**PETITION FOR VARIANCE
APPLICATION**

We are proposing a new building at 803 Williamson Street. Please see the attached drawings.

We are requesting a variance for IBC 1107.7.1, which requires "at least one story containing dwelling units.....be provided with an accessible entrance from the exterior of the structure **and all units.....on that story shall be Type B units**".

803 WILLIAMSON STREET
PROPOSED BUILDING
MADISON, WISCONSIN

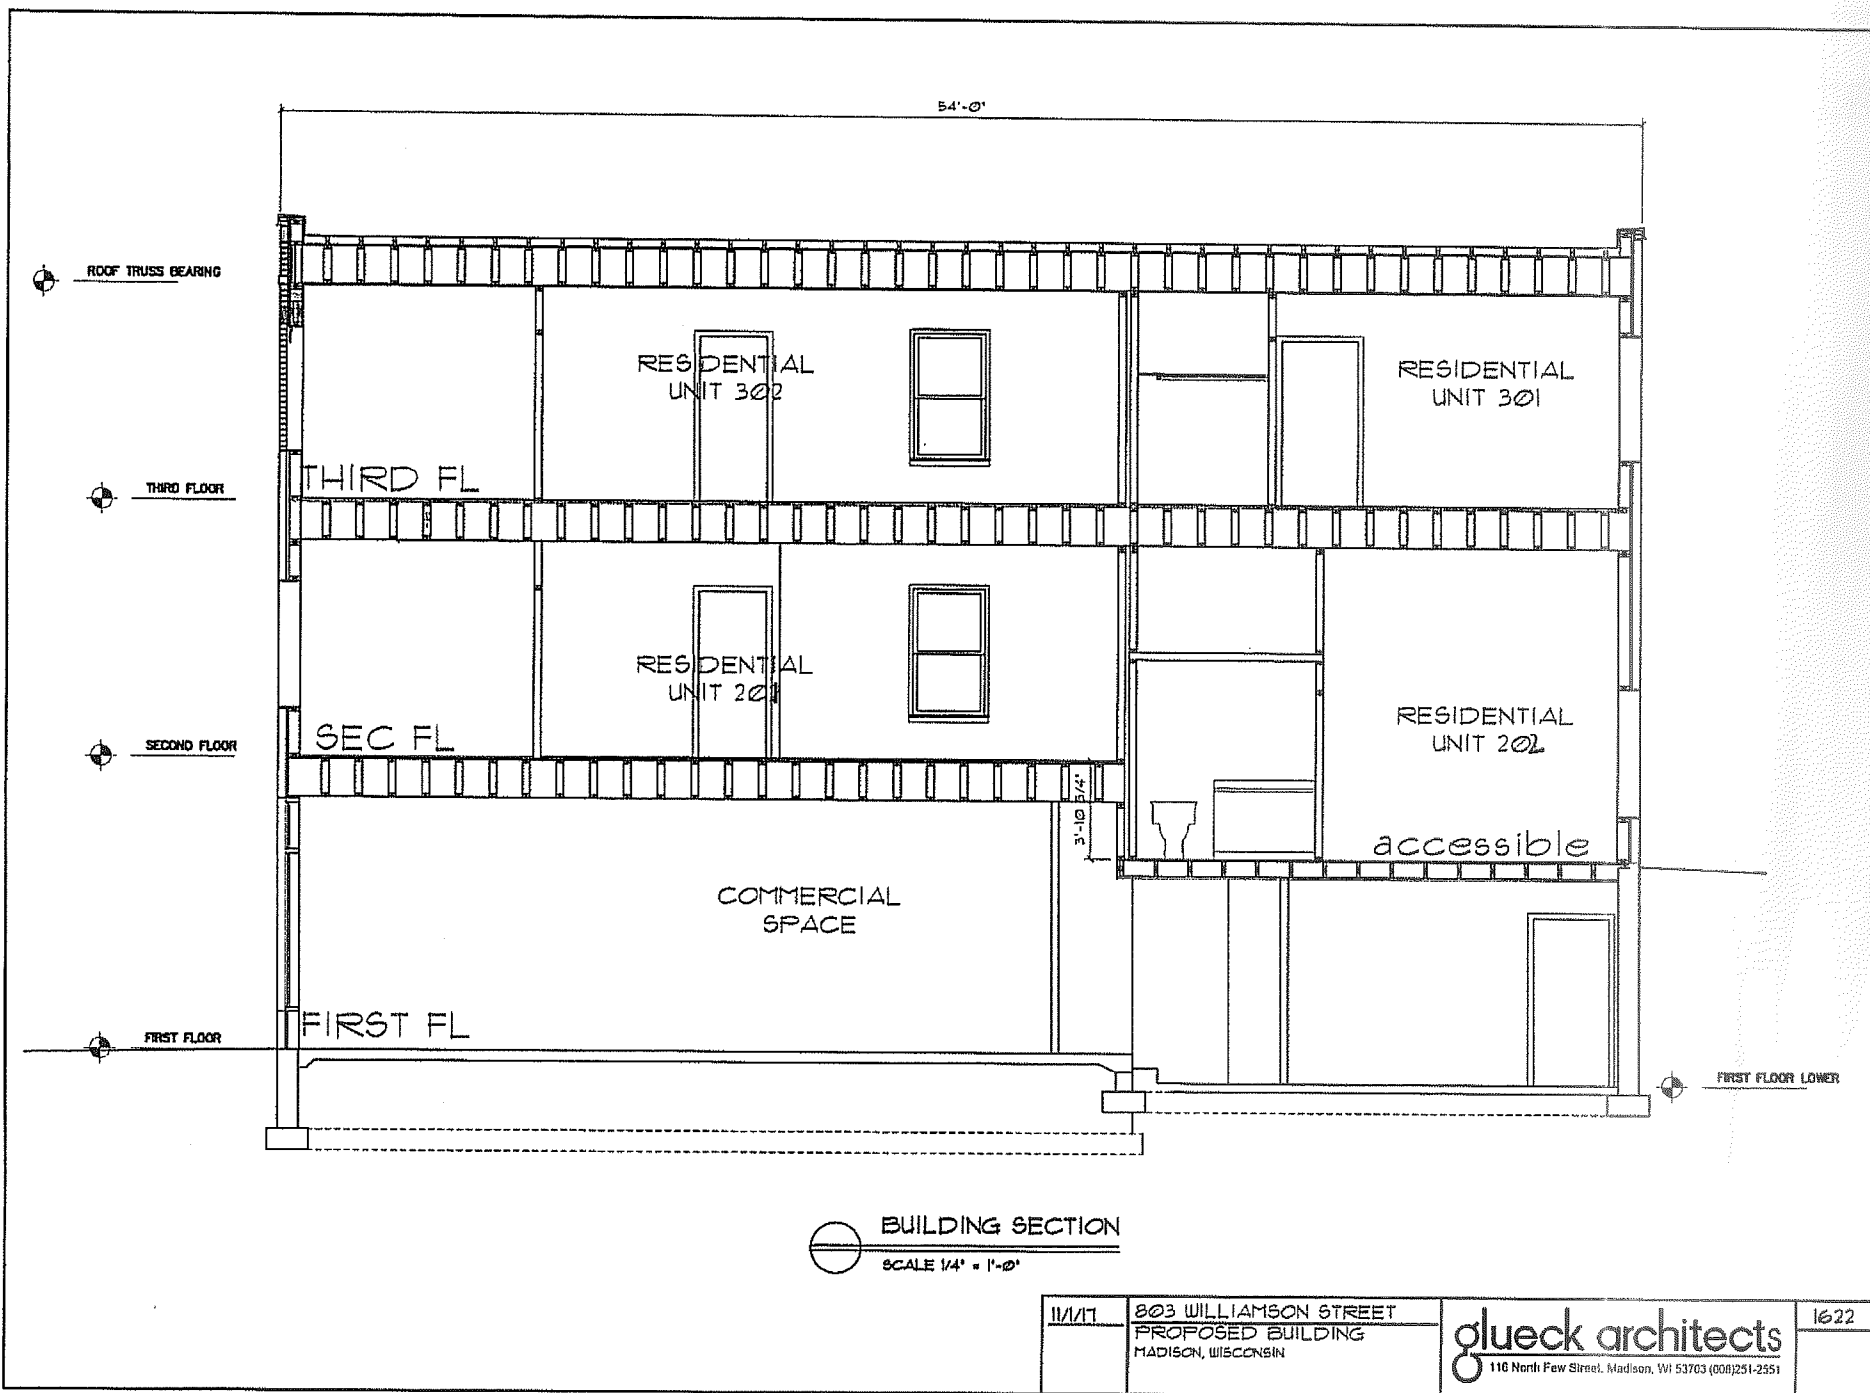
We are also adding Type B accessibility features to the front second floor unit as an extra measure for equivalency, as suggested by a board member at that meeting. Please see attached plan. Note widened doors and widened bathroom.
